INDESIT company

T5GR

F033768

Exploded views

5192290

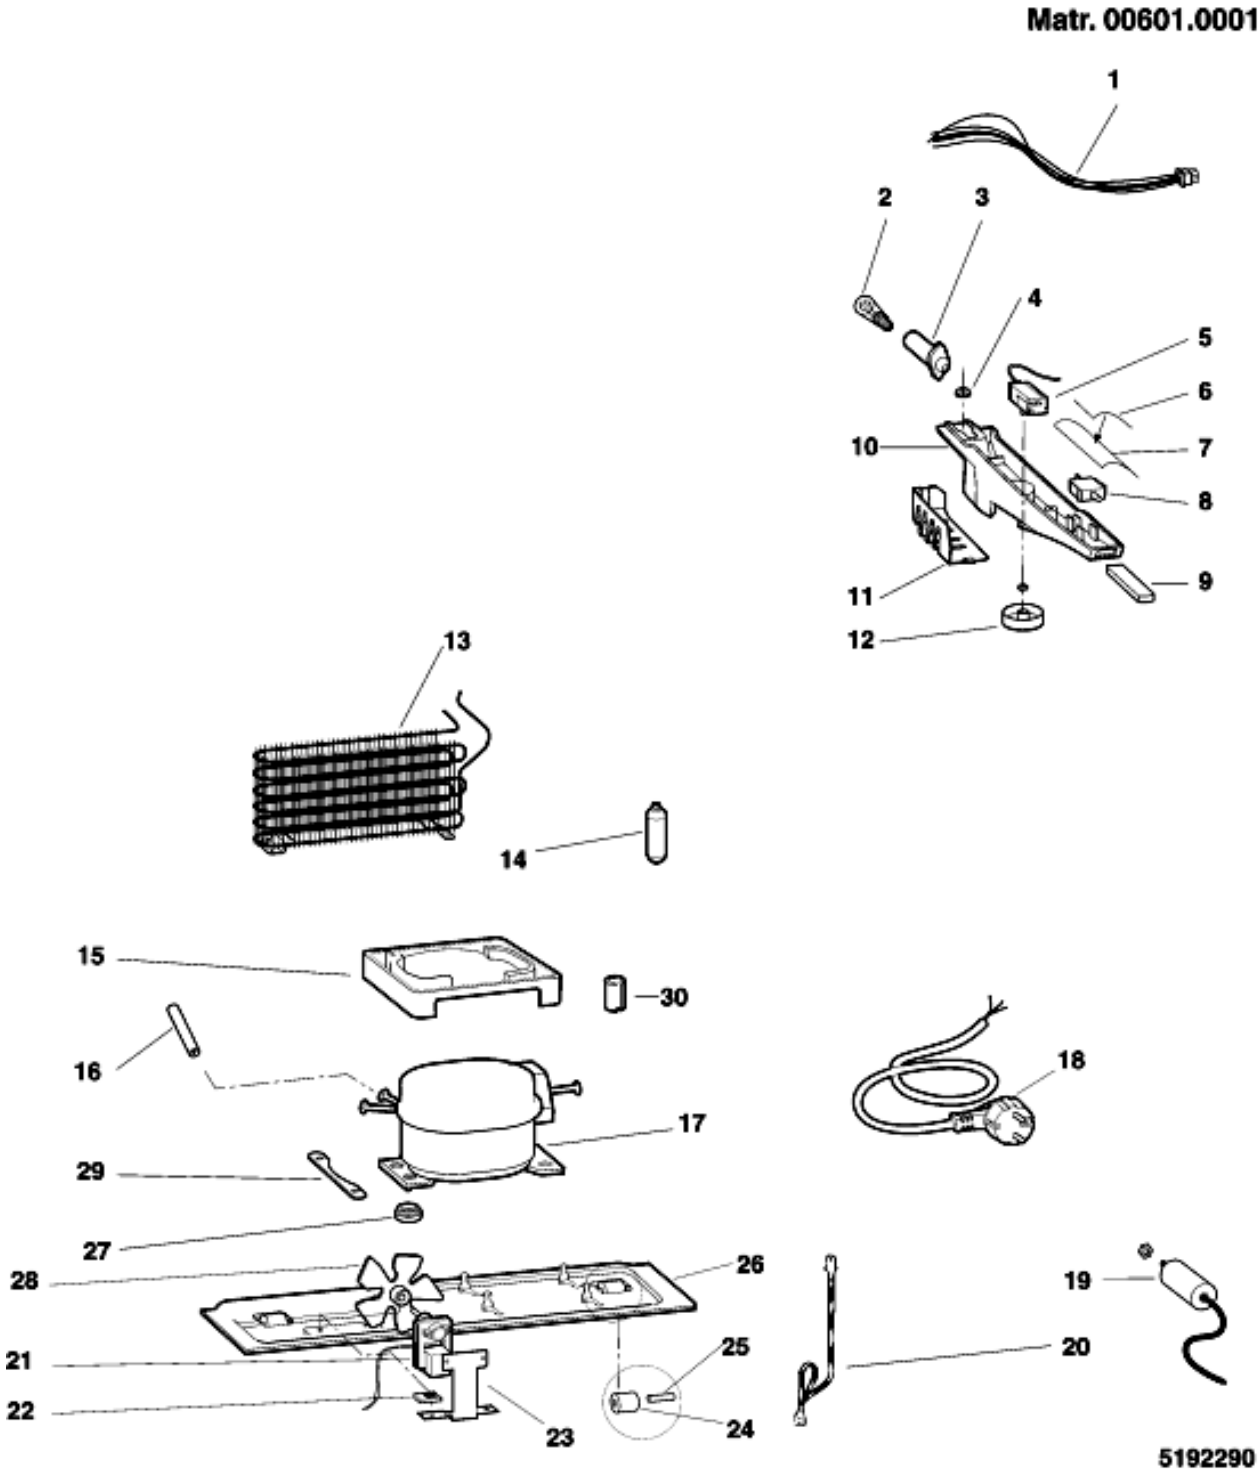
n2510b00: SUBSTITUTION RUBBER BUFFER FOR COMPRESSOR

Since month of February 2010 has been substitute in assistance the rubber buffer for compressor C00089673 with the C00109592.
Substitution is not valid for the products which use JIAXIPERA compressors respectively differentiate for type, Single Door (SD) / Double Door (DD) or different:

SD/DD C00089673 --> C00277320
NOT SD/DD C00089673 --> C00032453

RE0243T0 Exploded views

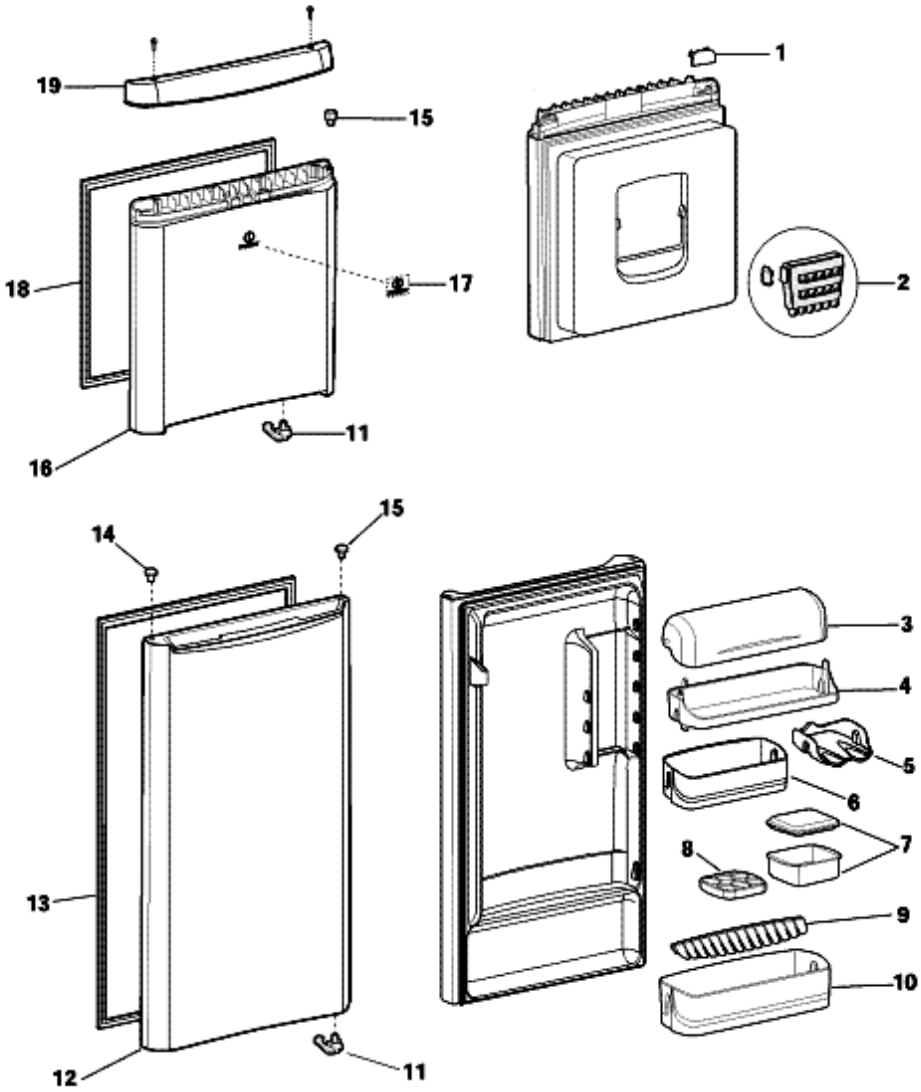
n2510e00: ELIMINATION OF ICE BOX INTEGRATED ON DOOR

From S/N 00218... on DD L70 models has been deleted ice box integrated in inner door and it has been substituted with door without integrated ice box plus added of "normal" ice box. At the end of stock will be managed only doors without integrated ice box.

SUBSTITUTED CODES ARE:

C00117948
C00098205
C00117771
C00110211

NEW CODES ARE:

C00196559
C00117027
C00252517
